File No. ACT/015/032

October 2, 1987

Genwal Coal Company has requested that I respond to Division questions regarding reclamation diversion channel RD-4 as currently proposed in the Permit Application Package. These questions concern (1) the dissipation of energy from the steep section of RD-4 (termed Section 3 in Appendix 7-7 of the PAP) at the head of the downstream mild section (Section 4 of Appendix 7-7) and (2) the abrupt nature of the confluence of RD-4 with RD-5.

ENERGY DISSIPATION BASIN
CENTER LINE SECTION

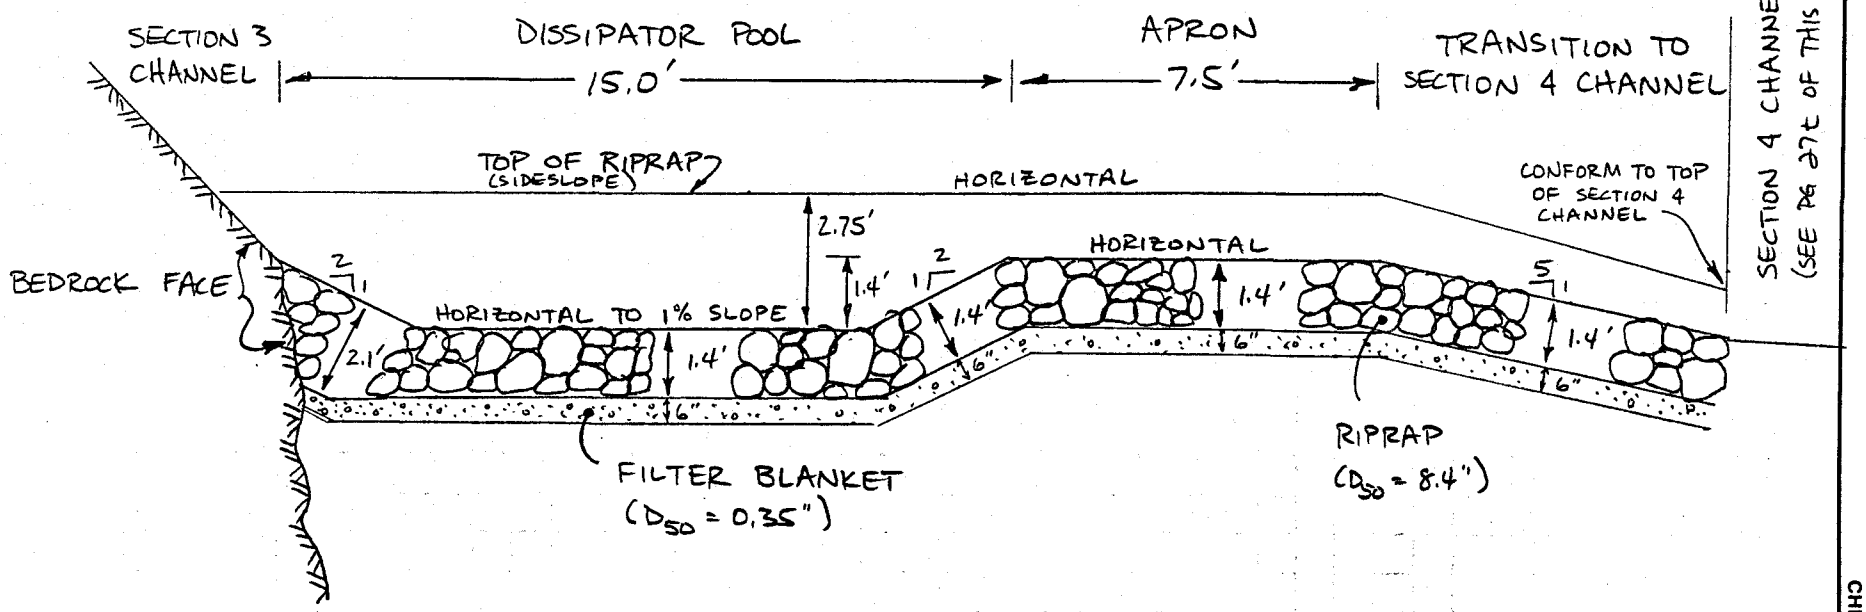
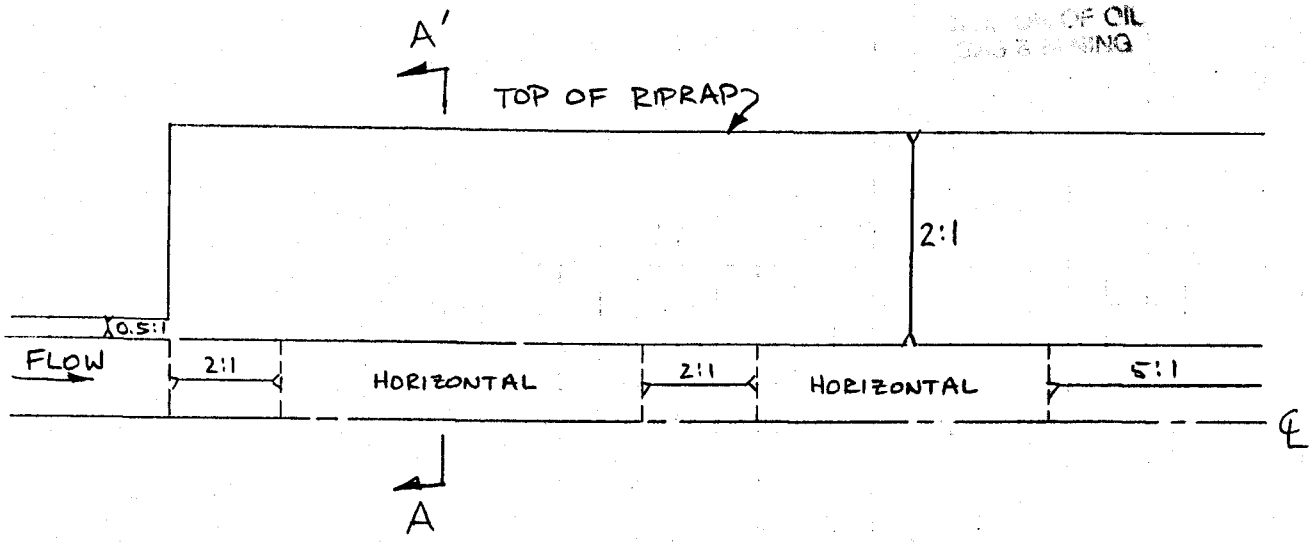
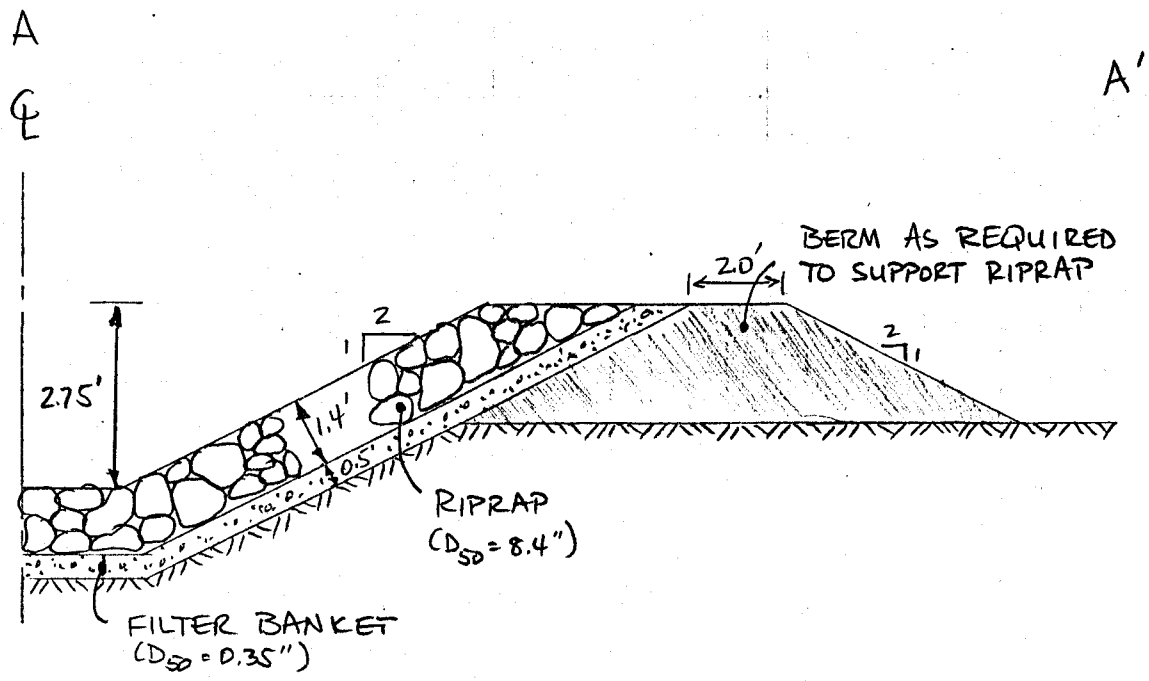
An energy dissipation basin has been designed in place of the splash apron previously proposed. This basin was designed in accordance with Hydraulic Engineering Circular No. 14 of the Federal Highway Administration. The design of this basin is provided in the attached calculation sheets (labeled as pages 27s2 through 27s6 and 27t). These pages (14 copies of which are included herewith) are to replace the present page 27t found in Appendix 7-7 of the PAP.

Basin length = $10 h_s = 14.3$ ft $\Rightarrow$ use 15 ft

Apron length = $5 h_s = 7.15$ ft $\Rightarrow$ use 7.5 ft

Total basin depth = $h_s + Y_0 + 1.0$
$= 1.43 + 0.20 + 1.00$
$= 2.63$ ft $\Rightarrow$ Construct with depth = 2.75 ft
